Groundwater Transfer Review Summary Form

Transfer/PA # T- 14394 (RA)

Application: T-14394

Applicant Name: City of Junction City

Figure 1. Estimated time-drawdown at maximum allowable rate.

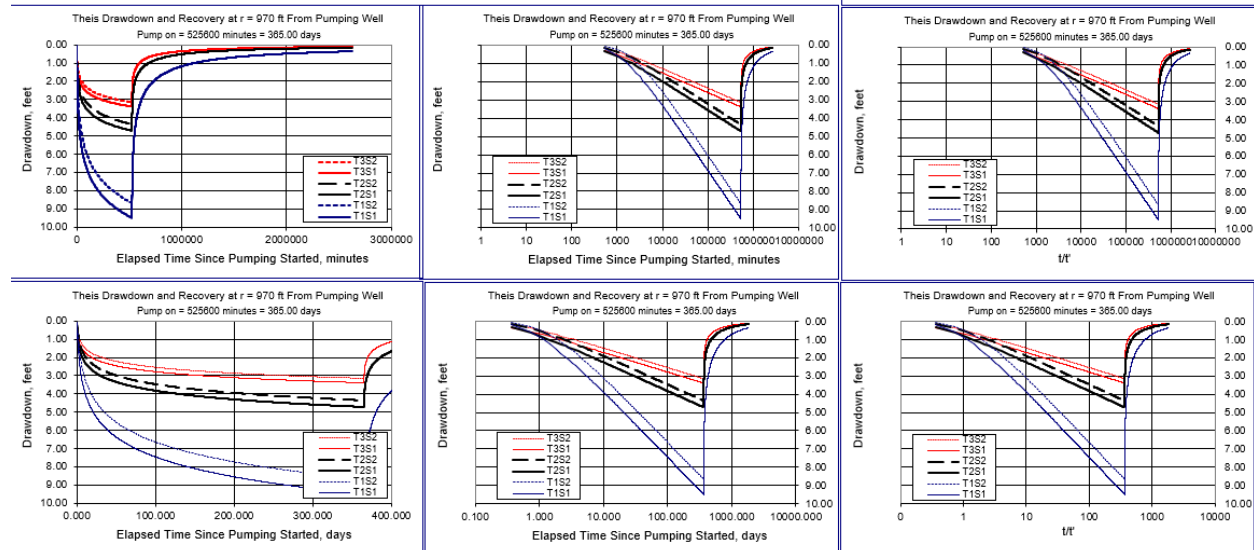
4. a) Will this proposed change, at its maximum allowed rate of use, likely result in an increase in interference with **another ground water right**?
☒ Yes ☐ No Comments: The maximum allowed combined rate of Certificates 46412 and 65071 is 2.03 cfs (911 gpm). The closest water well (LANE 7798) is 970 feet from the proposed POA. Modeling with conservative hydraulic parameters indicated drawdown at LANE 7798 would likely be less than 10 feet when pumping the proposed To-POA at the maximum allowable rate of 2.03 cfs.

Theis Interference Analysis

Hydraulic Conductivity: Values ranged from 25 ft/day (LANE 8061 pump test, assuming 82-foot aquifer thickness) to 220 ft/day (Conlon et al., 2005). The final transmissivity estimates of 8,823, 20,230, and 29,750 were the 1st, 2nd, and 3rd quartiles from 200-model runs using a range of the previously stated hydraulic conductivity values.

Storativity: 0.0003 to 0.07 (Woodward et al., 1998; Conlon et al., 2005, Table 1).

Time: 365 days.

Rate: 2.03 cfs (maximum rate) for the To-POA; 0.67 cfs (one-third maximum rate) for the To-POA

Distance: 970 feet from the To-POA to LANE 7798.

☐ Yes ☒ No If yes, explain: The modeled interference is unlikely to result in injury for a fully penetrating, reasonably efficient neighboring well. LANE 7798 and other neighboring wells do not fully penetrate the aquifer.
